January 10, 2025

Willis V. Carrier Recreation Center
Town of DeWitt
Project No. TOD PH3

Addendum No. 1

AD1-A1

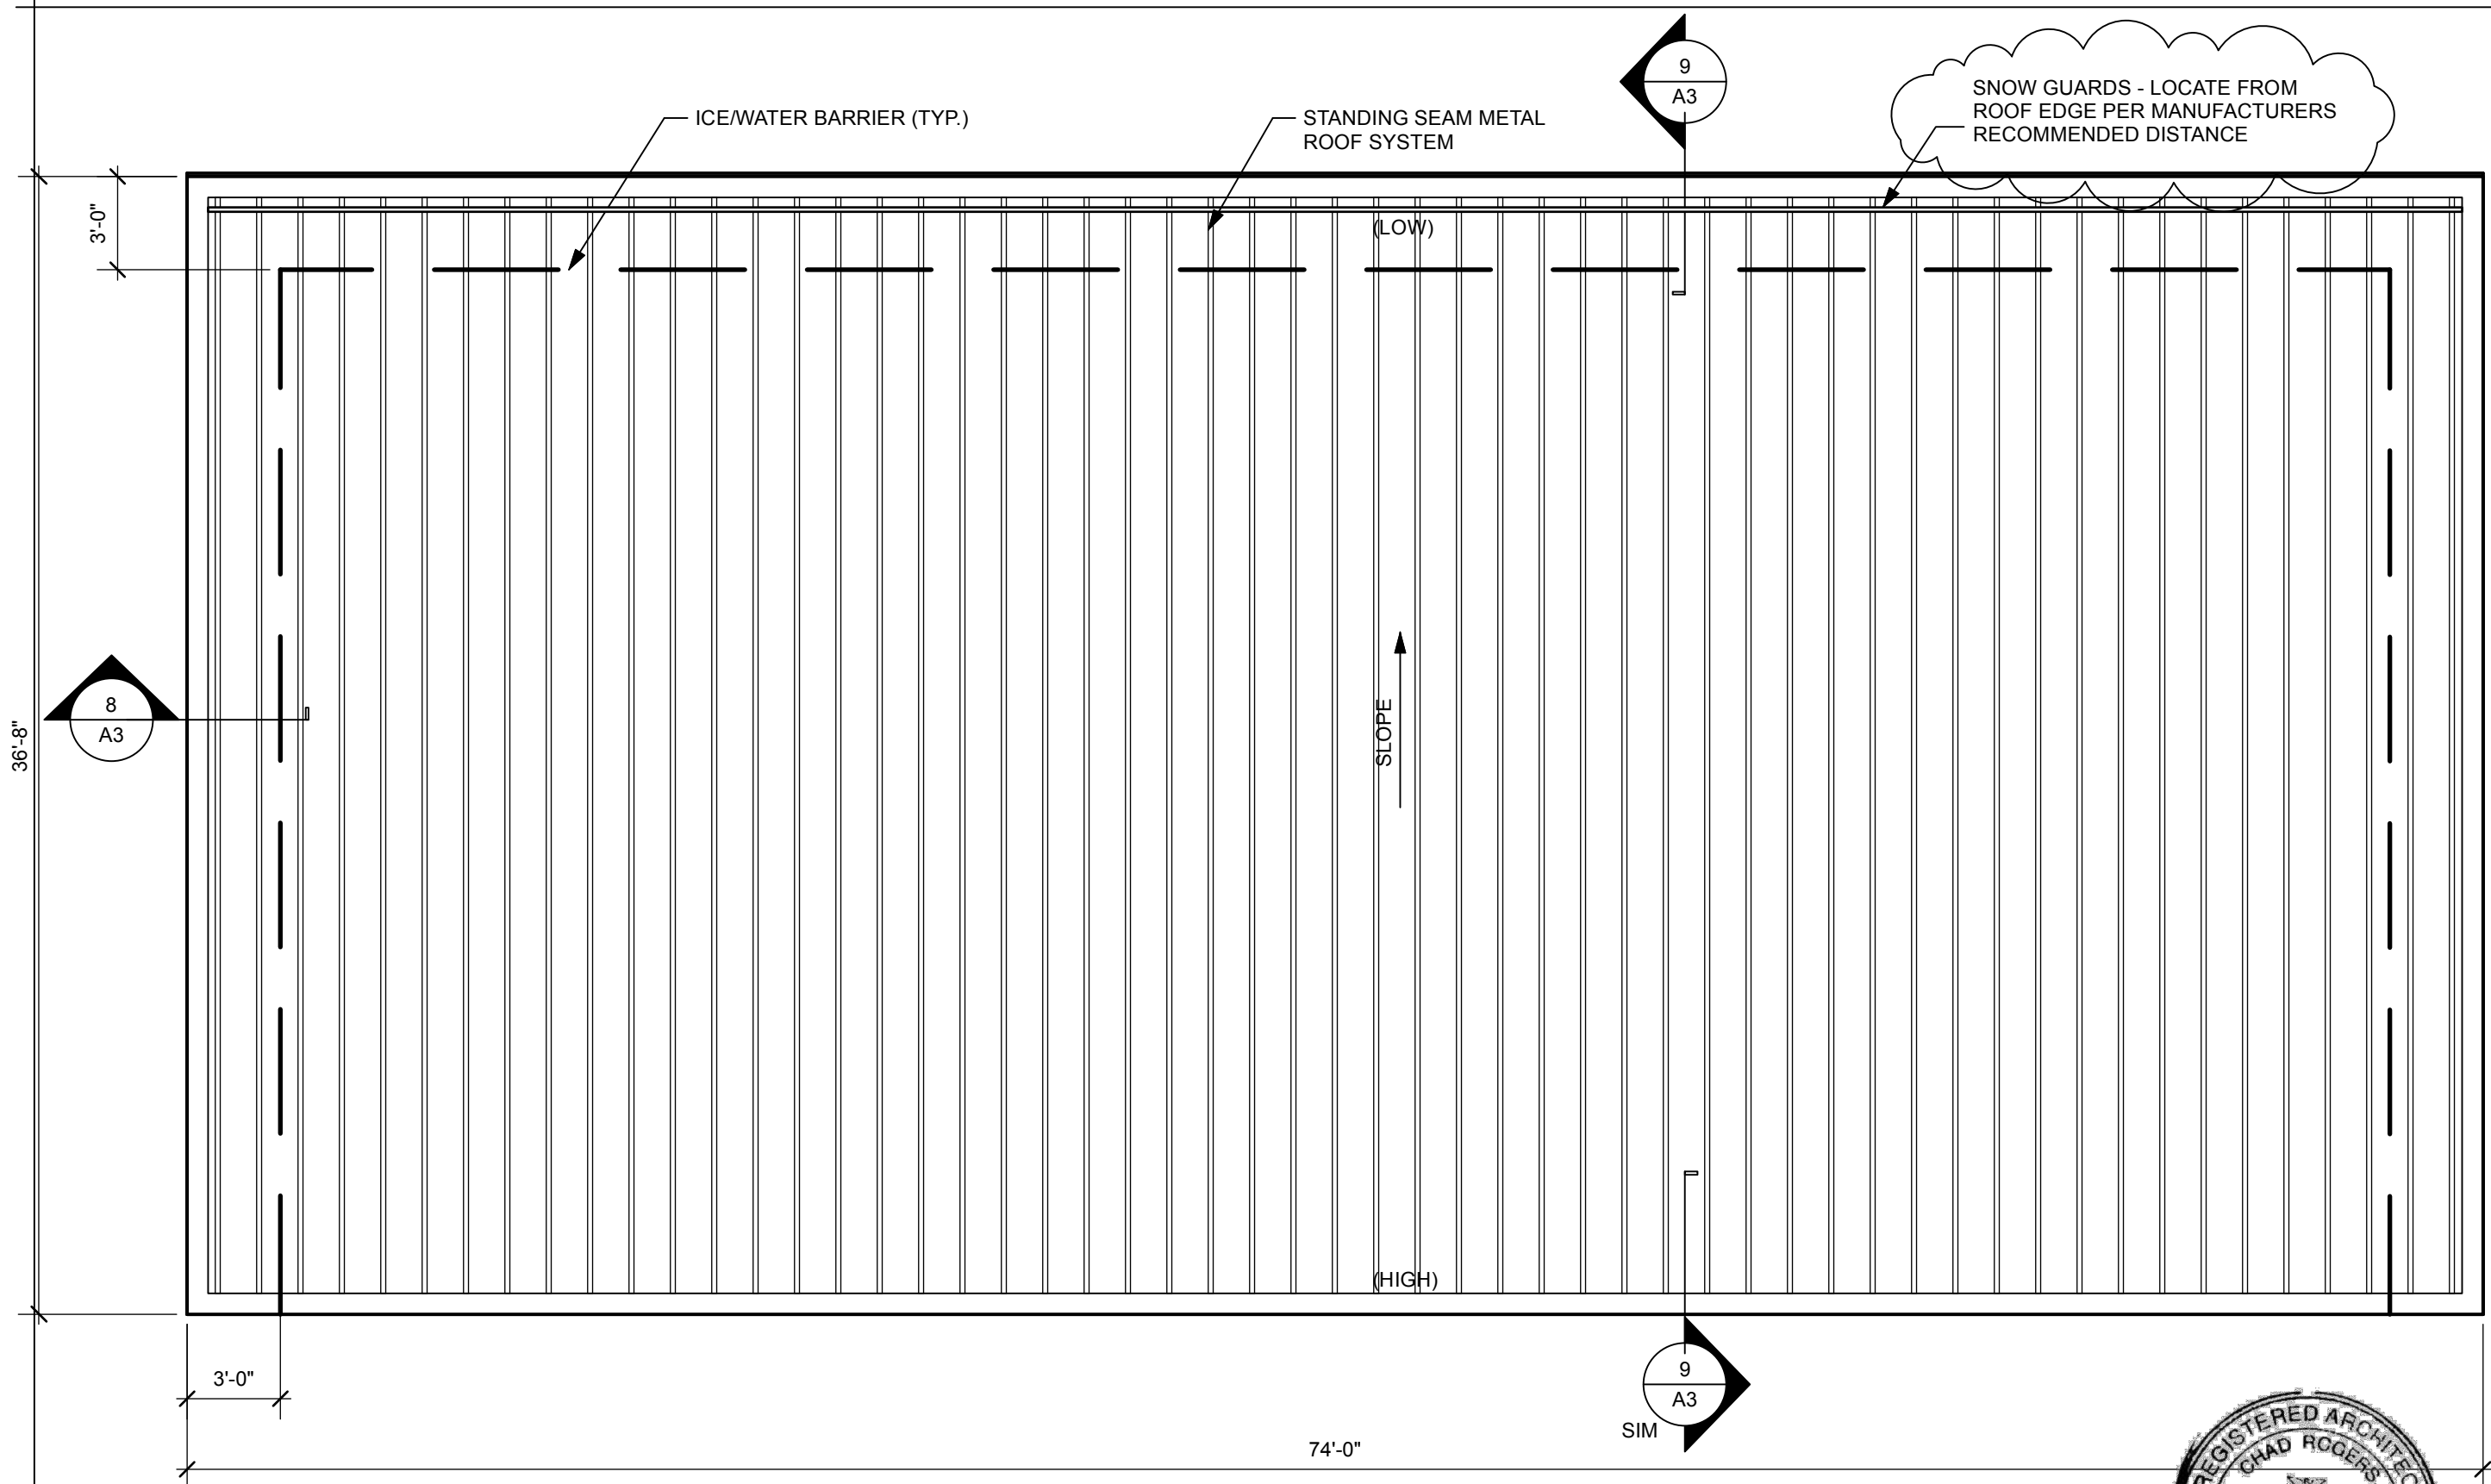
1. Detail 3/A2 TOILET ROOM BUILDING – ROOF PLAN: **REPLACE** detail in its entirety with the attached addendum drawing “**AD1-A1**”.
 - 2.Detail 2/A2 – TOILET ROOM BUILDING – REFLECTED CEILING PLAN: **MODIFY** detail as shown on attached addendum drawing “**AD1-A4**”.

2 ROOF PLAN - MAINTENANCE BUILDING

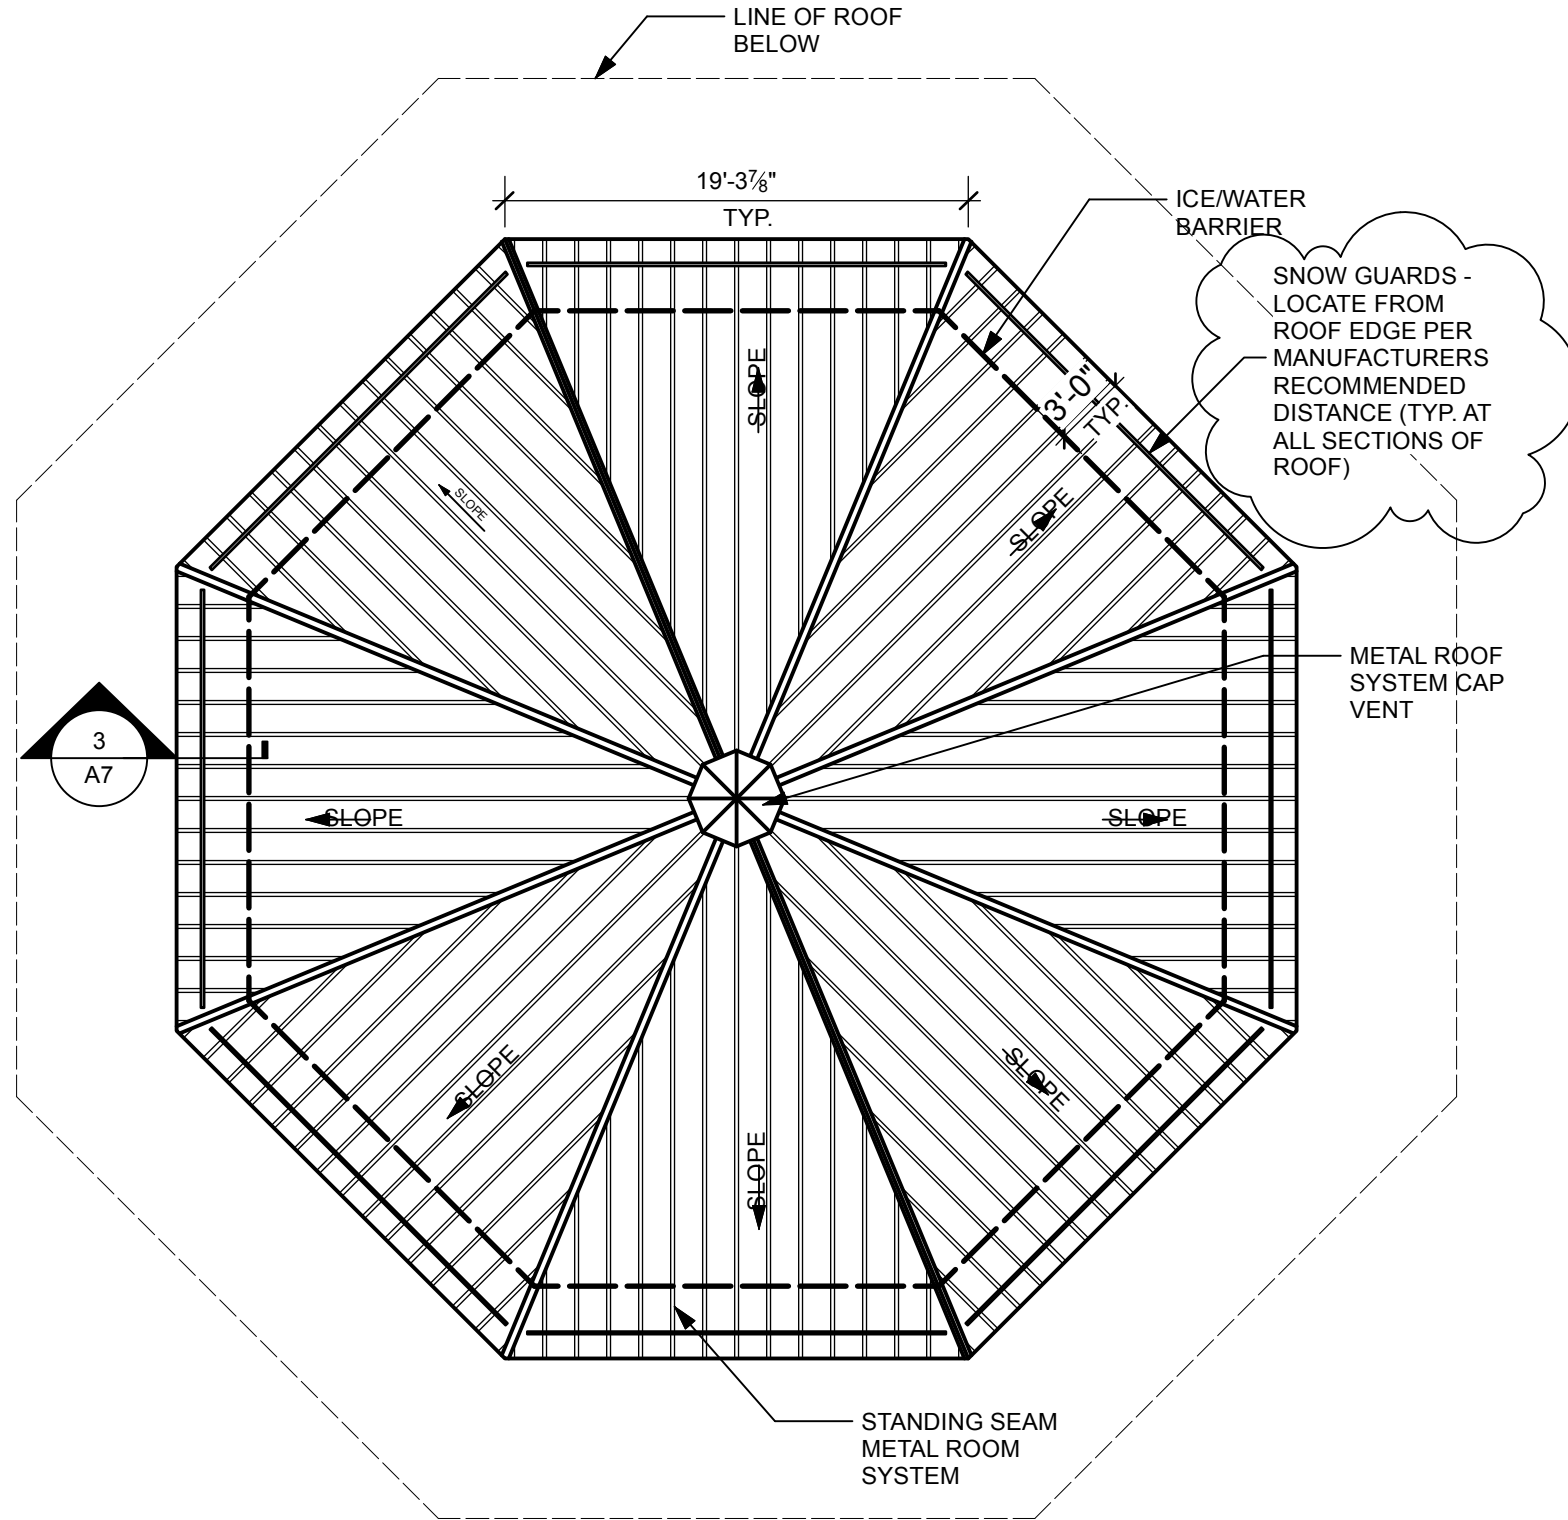
- k. On sheet A3:
 1. Detail 2/A3 ROOF PLAN – MAINTENANCE BUILDING: **REPLACE** detail in its entirety with the attached addendum drawing “**AD1-A2**”.
- l. On sheet A6:

1 UPPER ROOF PLAN
AD1-A03 1 of 2 Scale: 1/8" = 1'-0"

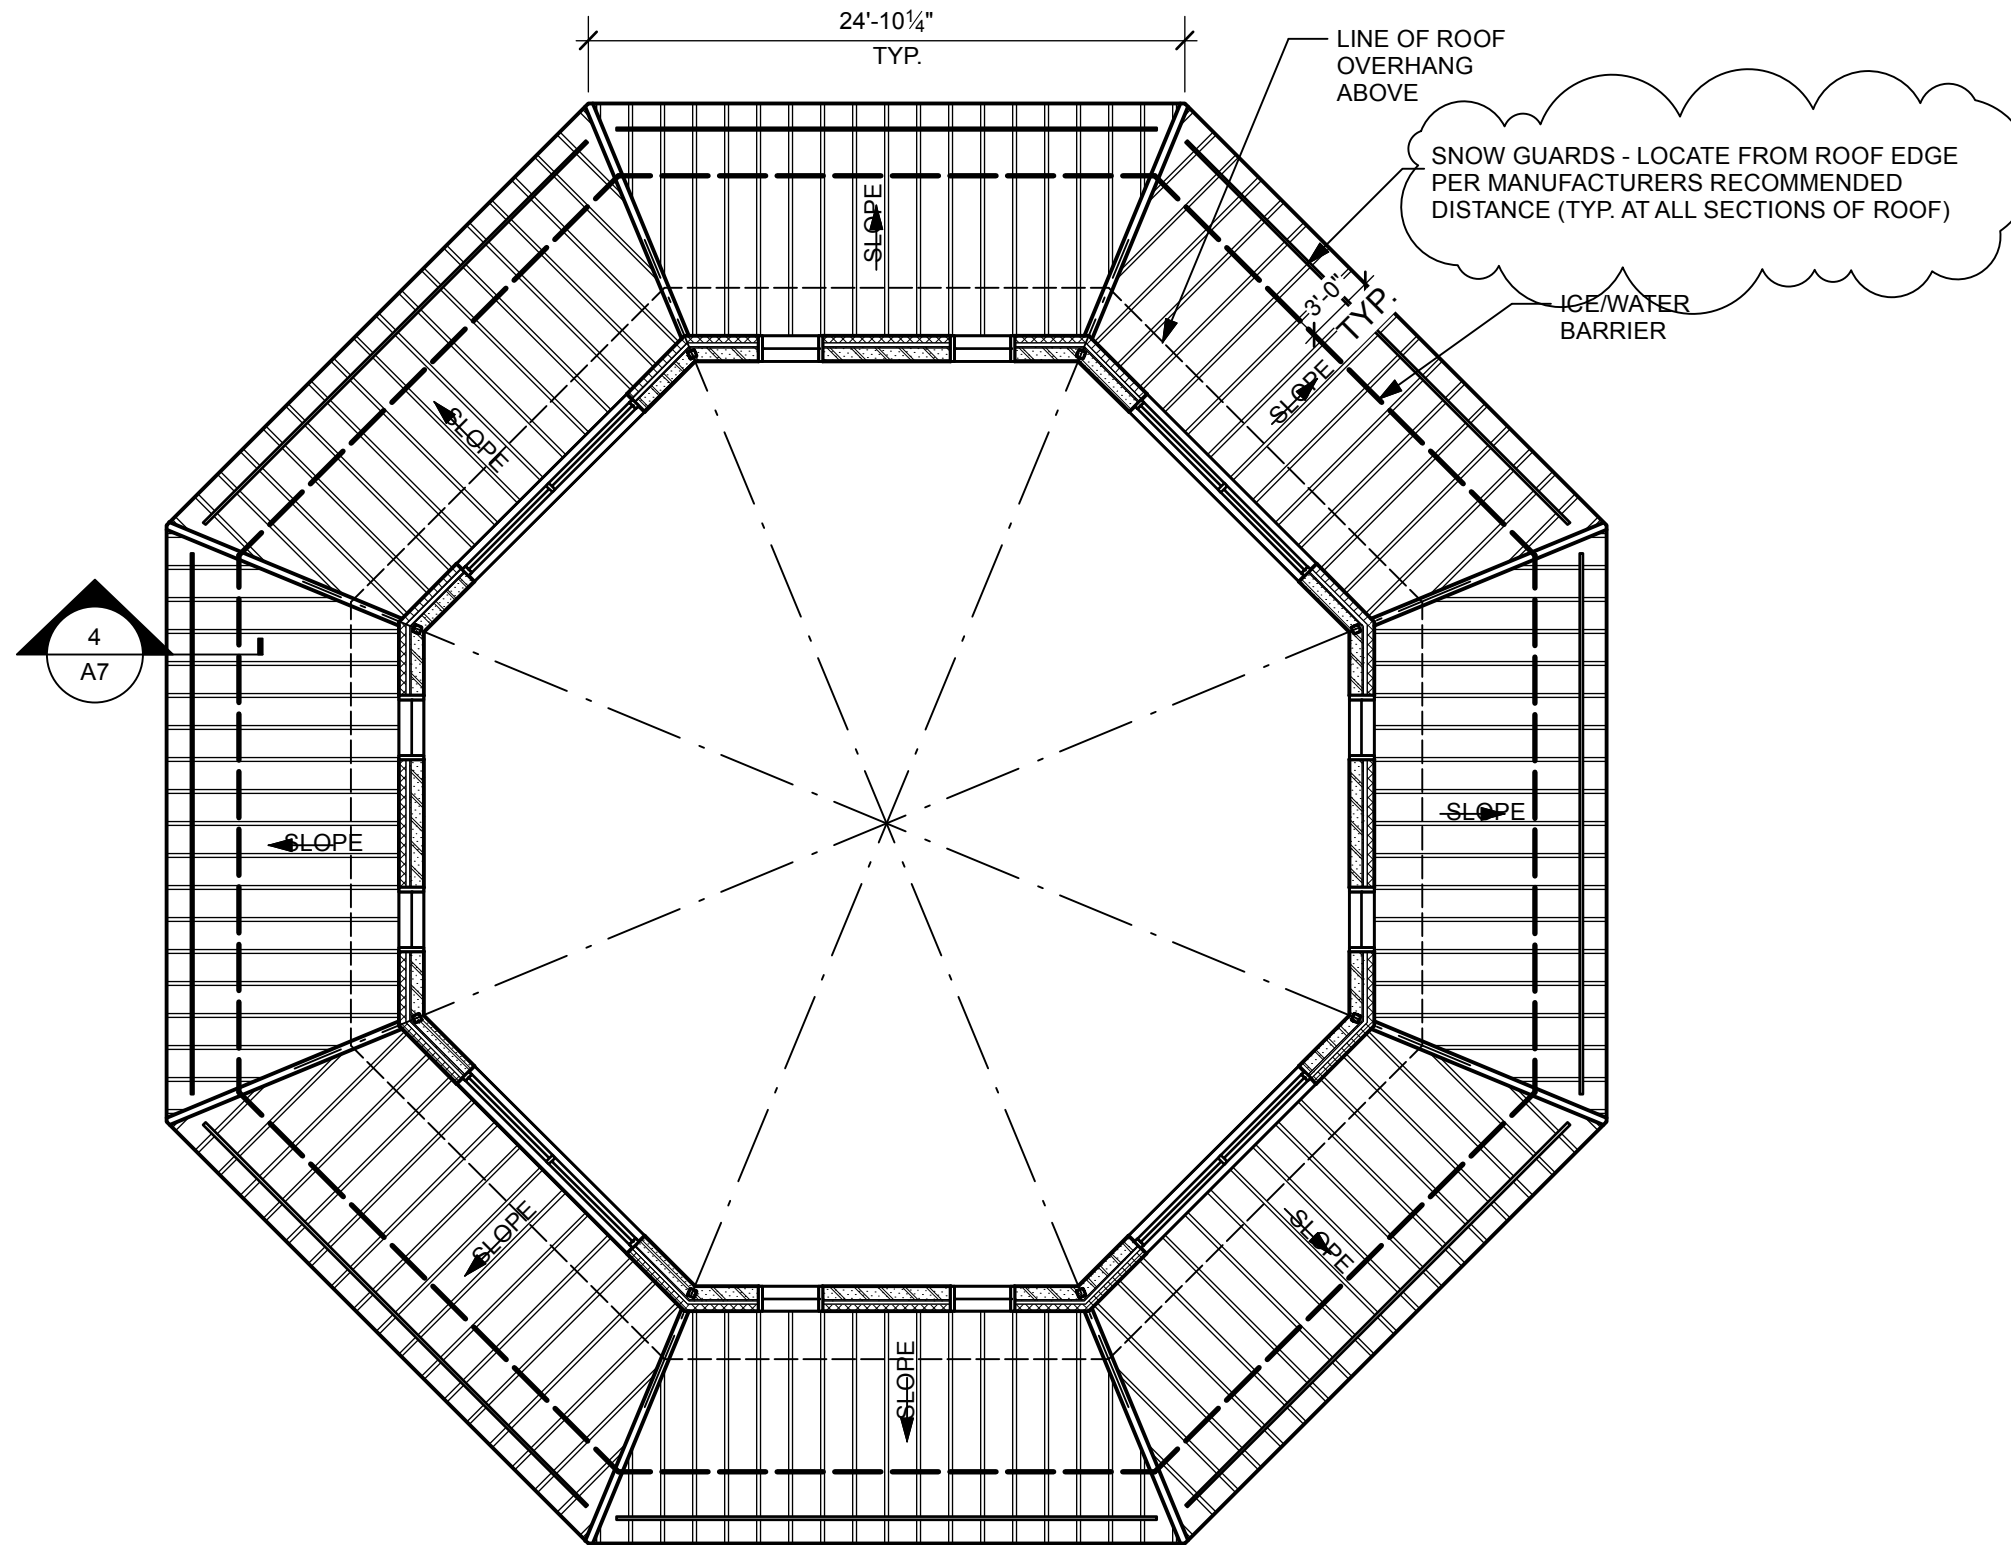
- 1.Detail 4/16 – PLAN DETAIL: **CHANGE** “*2” Rigid Insulation*” to read “**2-1/2” RIGID INSULATION**”.
- m. On sheet A7:
 - 1.Detail 1/A7 UPPER ROOF PLAN: **REPLACE** detail in its entirety with the attached addendum drawing “**AD1-A3 (1 of 2)**”.
